DELAWARE RIVER AND BAY AUTHORITY

WILMINGTON AIRPORT

ADDENDUM NO. 1

DEPARTURE LOUNGE CONCESSION AREA

C-A-100R1

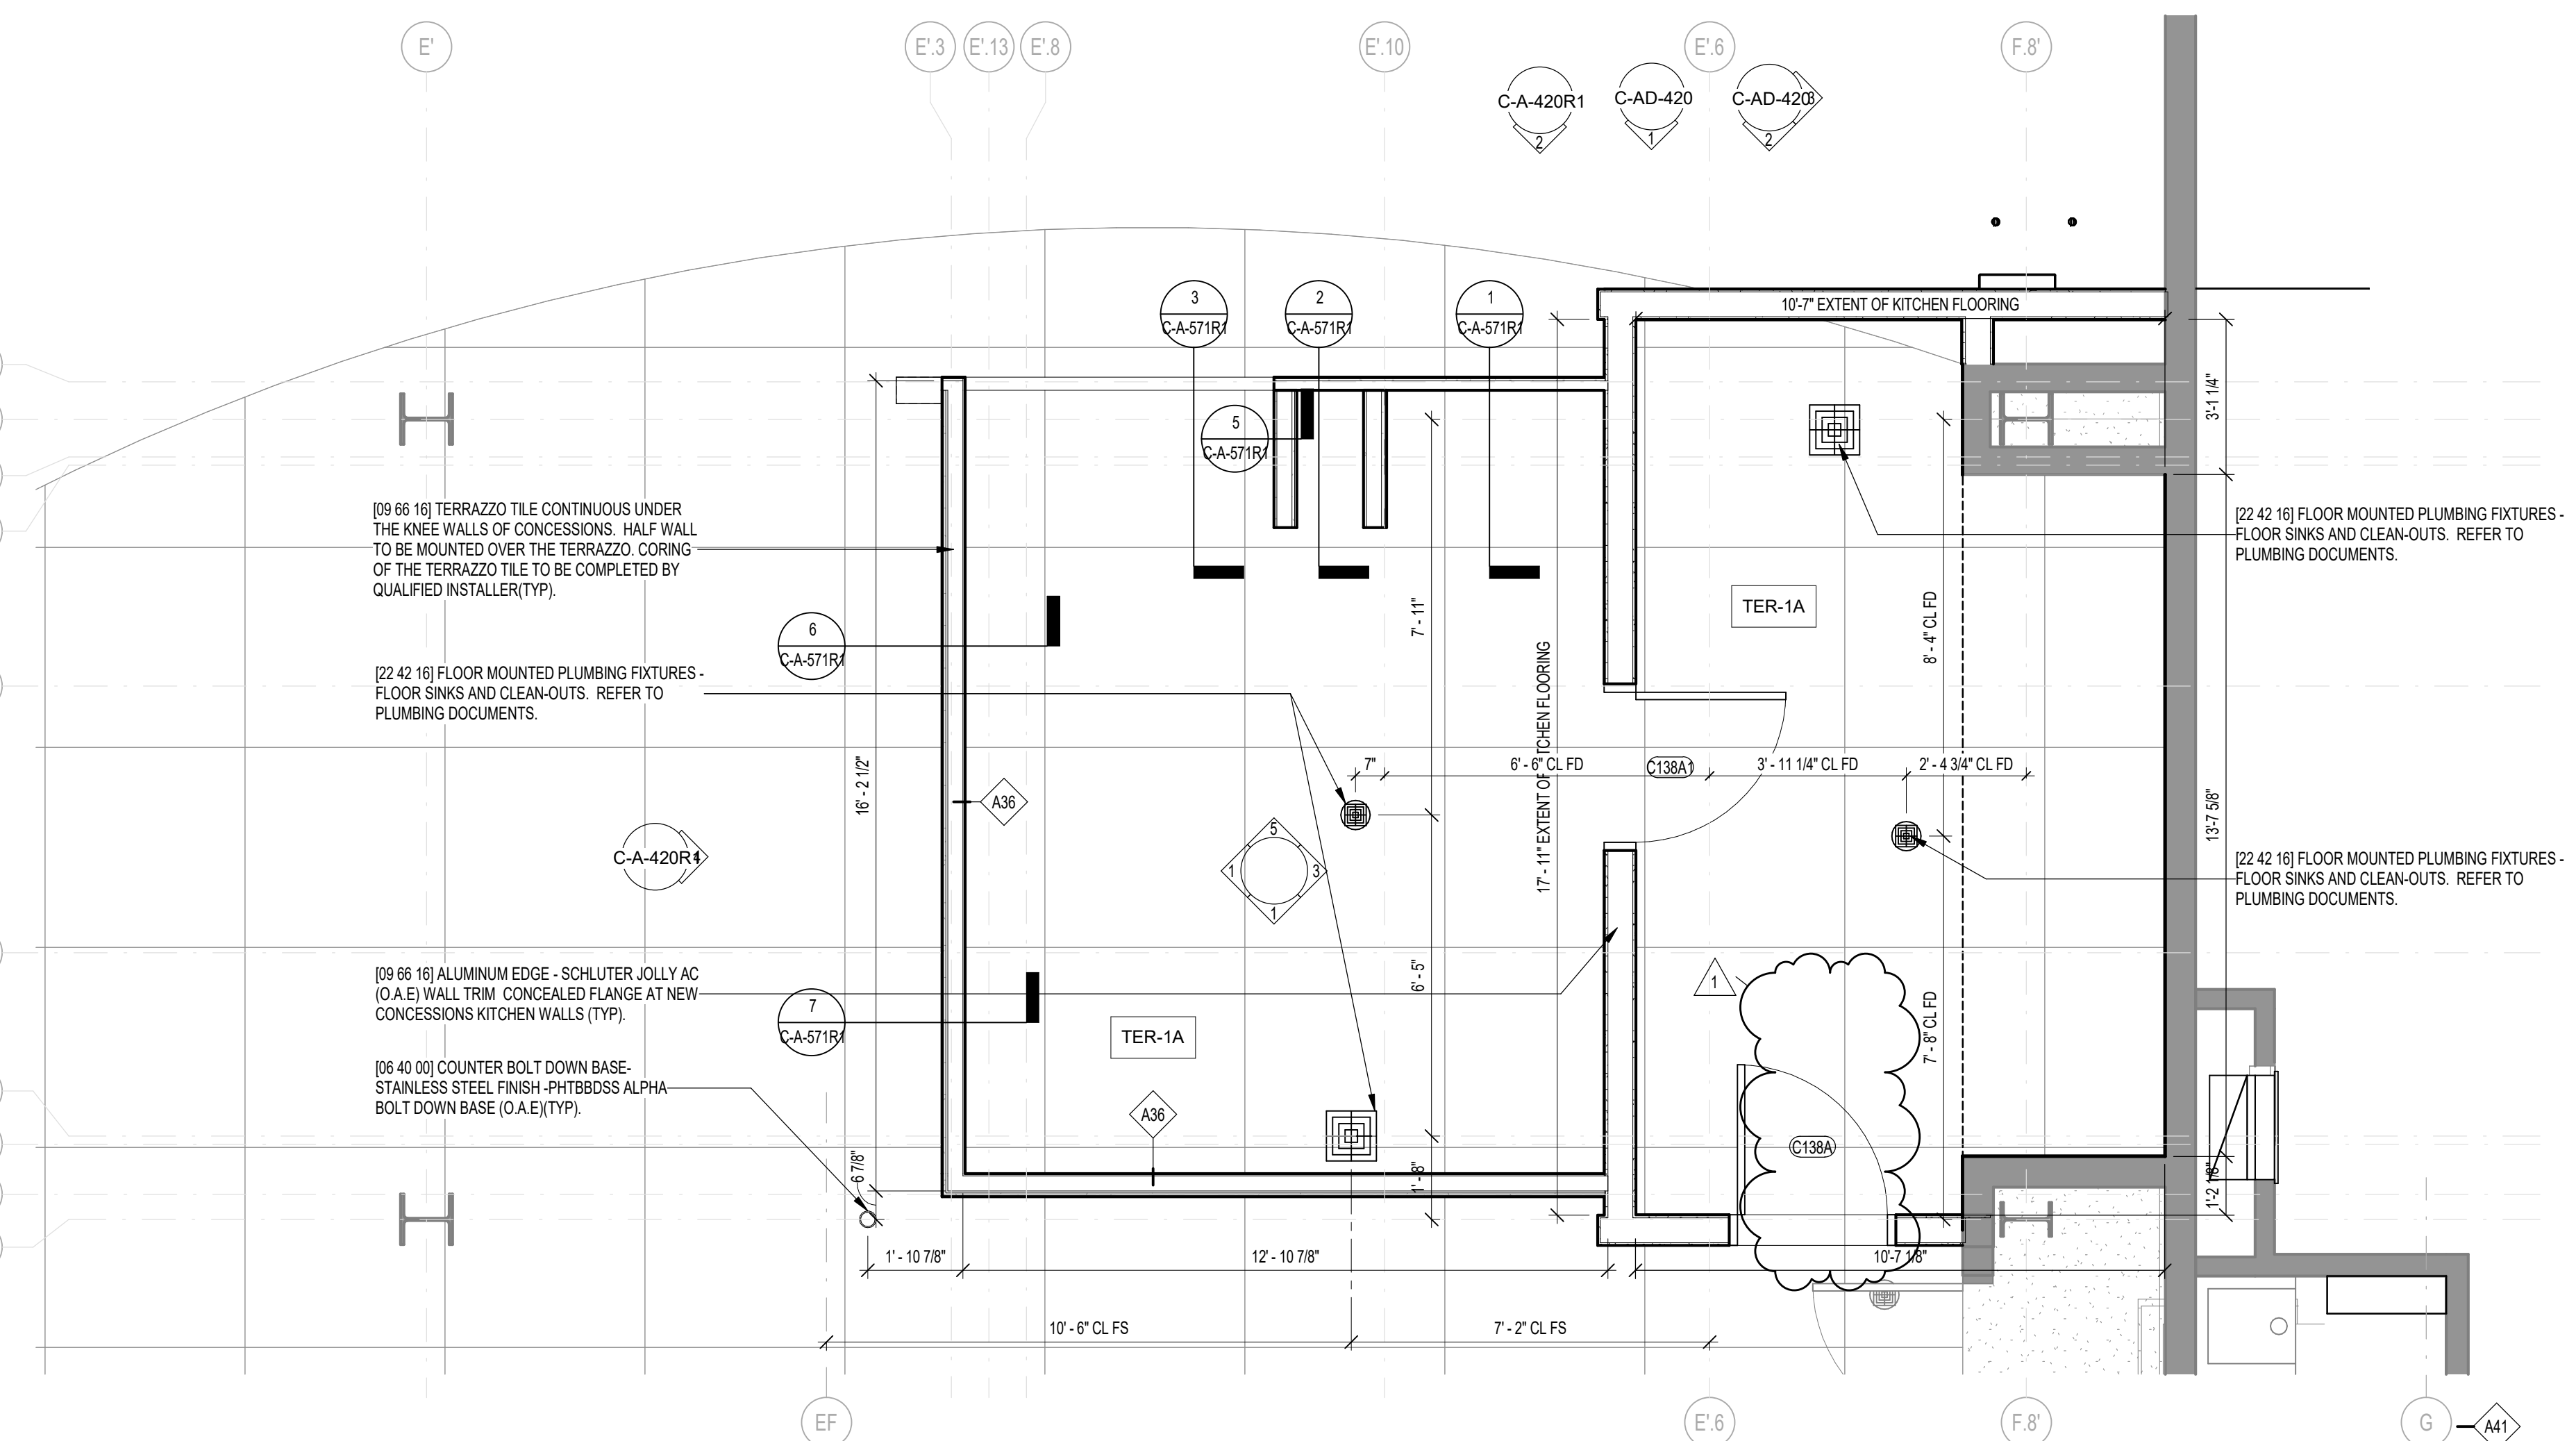
- A6. See Amendment No. 1. Corian; thickness dimensions on Plan Sheet A-571 have been updated.
- Q7. Plan Sheet A-100 has reference tag as #5 but there is not an elevation 5 on any of the plan sheets. We need the elevation 5 to see what you want for millwork under the countertop. Designer White is only available as a solid surface color. DuPont only offers ¾" thick solid surface in glacier white and cameo white, which is non-stock / special order / available in pallet quantities of 7 sheets. The sheet size is ¾" x 30" x 144". Otherwise, Designer White is available in ¼" x 30" x 98" sheet size, but this material is also non-stock / special order / available in pallet quantities of 16 sheets.

- A8. Refer to Q6 above.
- Q9. The partition legend on Plan Sheet A-100 references Plan Sheets A601 and A602. These sheets have not been provided.
- A9. See Amendment No. 1. Plan Sheet A-100 has been updated to reference Plan Sheet A-541. Plan Sheets A-601 and A-602 do not exist in this plan set.

- A7. See Amendment No. 1. Elevation 5 in Plan Sheet A-420 has been updated to include the millwork shown in the corresponding detail 2 in Plan Sheet A-571. Refer to A6 regarding solid surface.

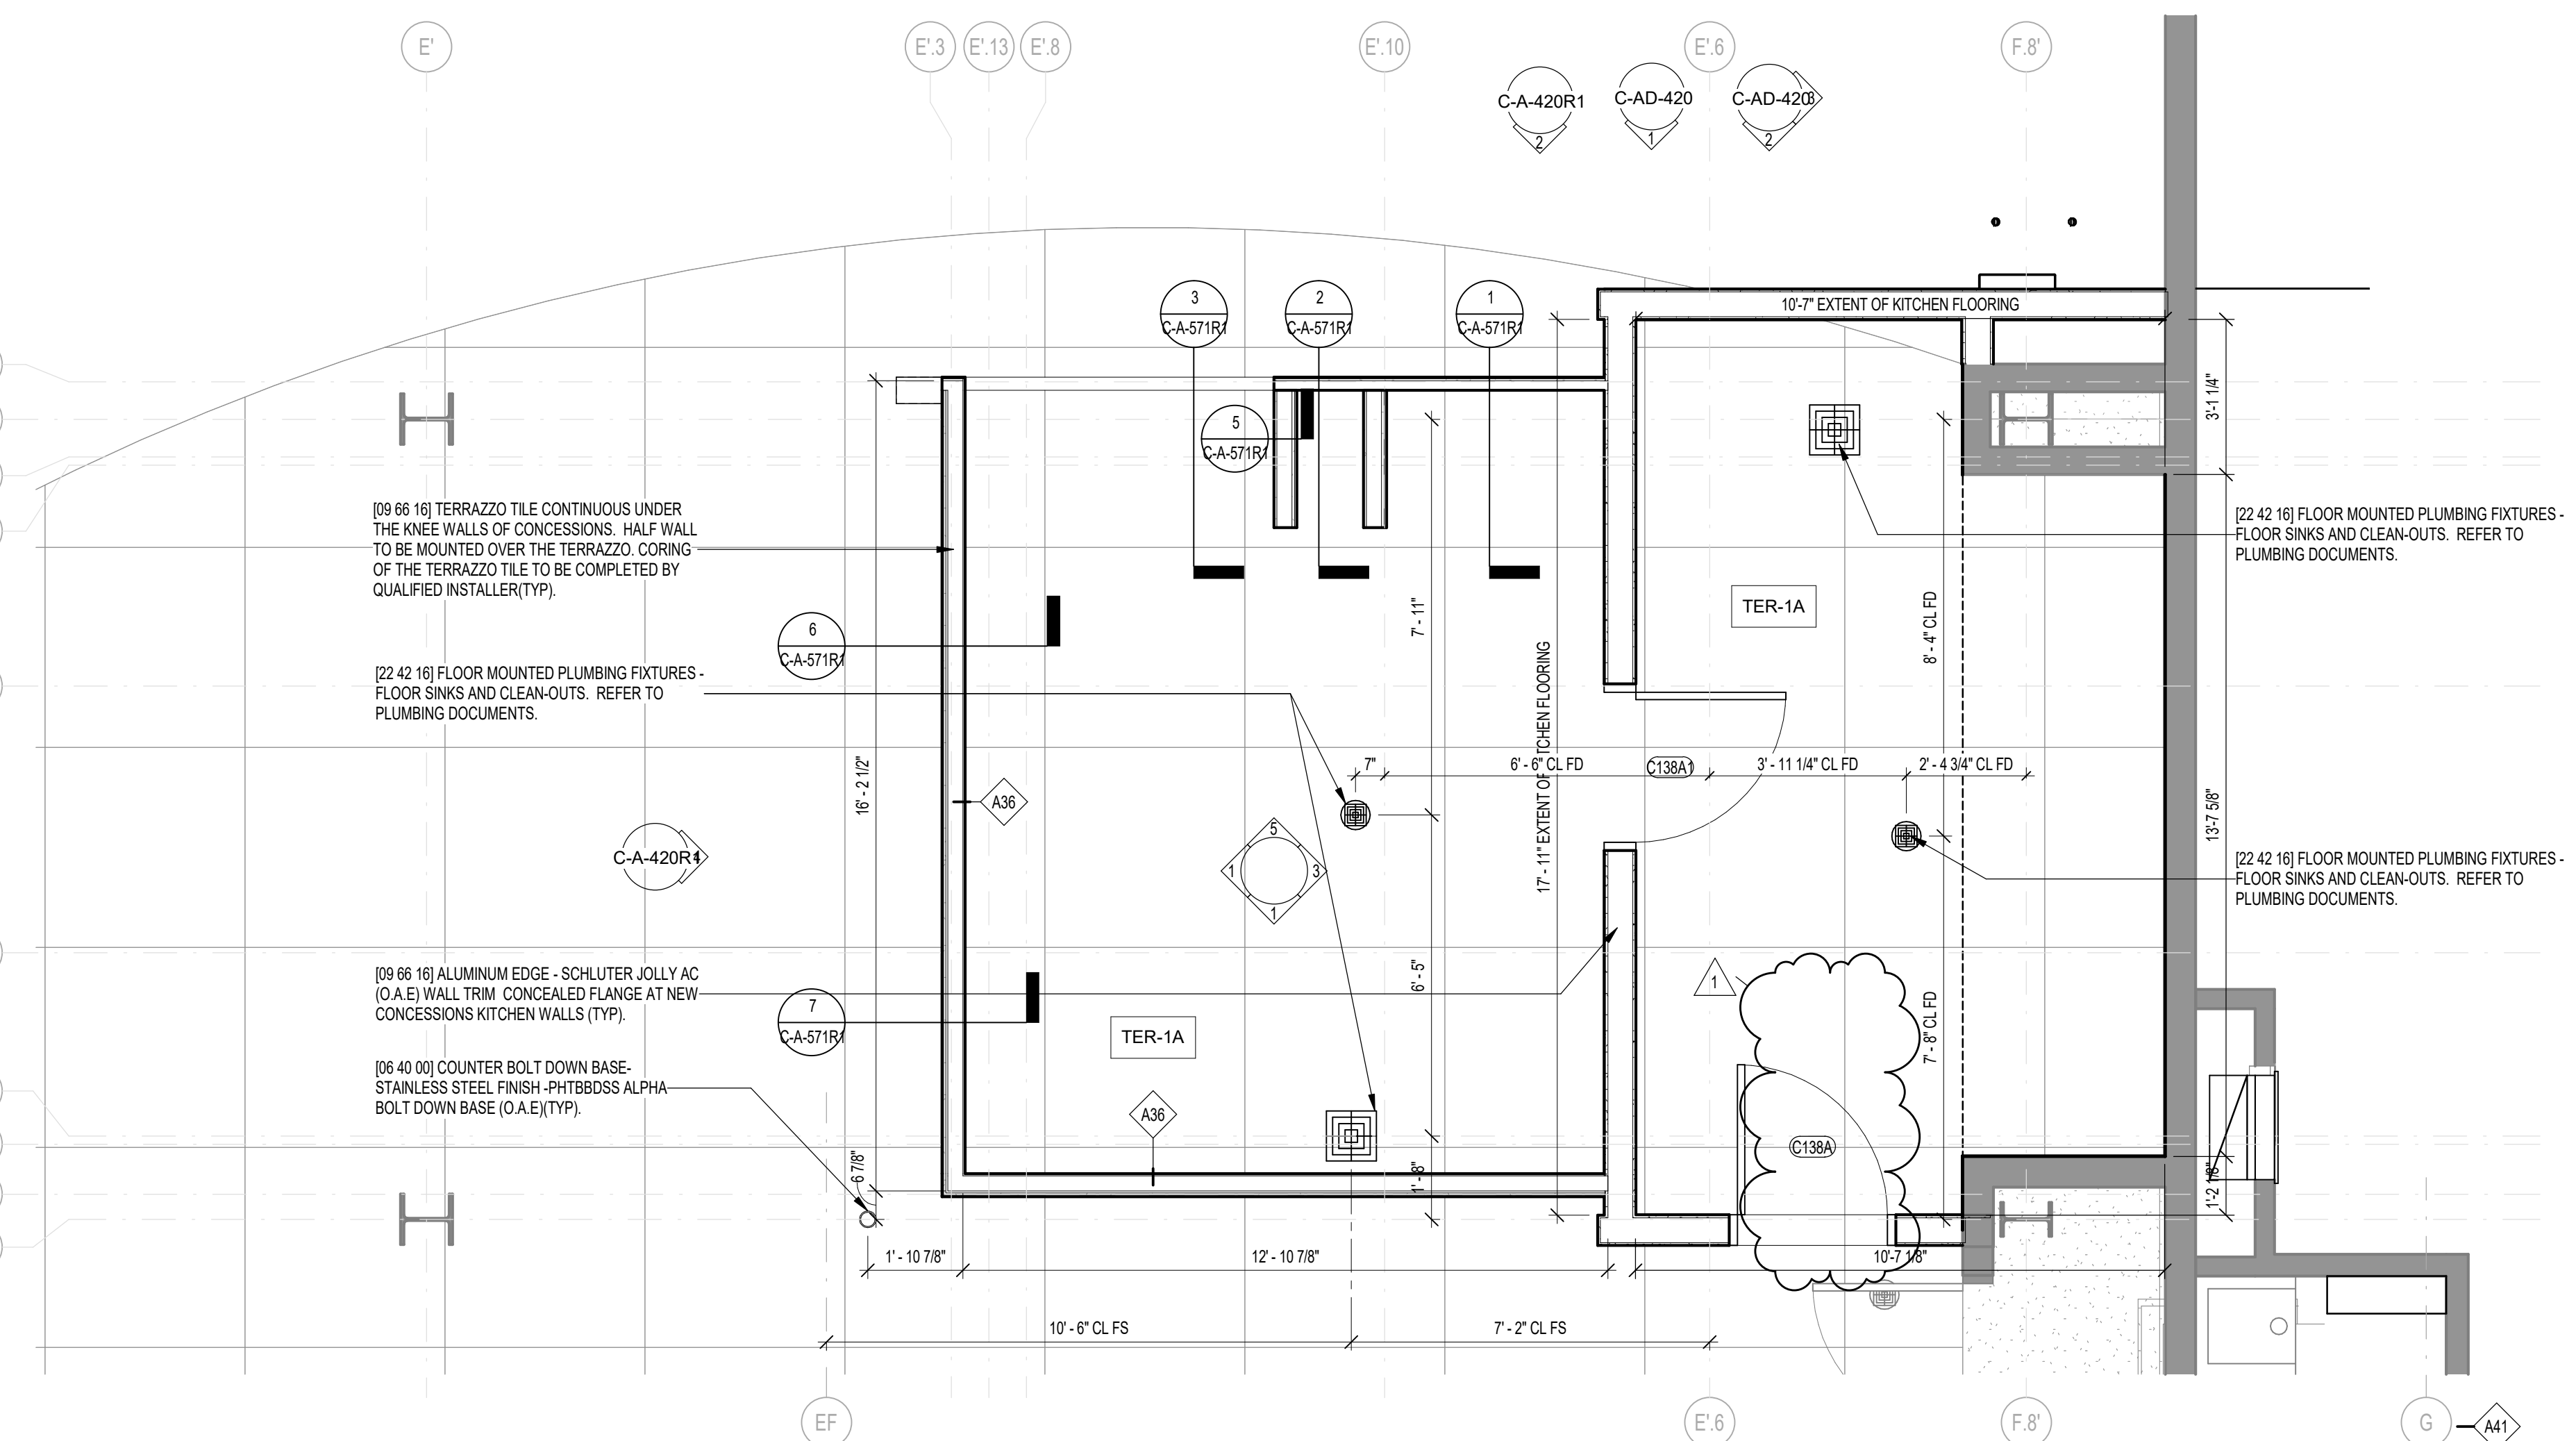
- Q4. Please confirm that ACT 2 is Armstrong Metalworks per the specifications, opposed to the finish materials key on Plan Sheet A-120.
- A4. Correct, ACT 2 is an open metal system noted in Section 095100. See Amendment No. 1. The RCP note and the material legend on Plan Sheet A-120 have been updated.
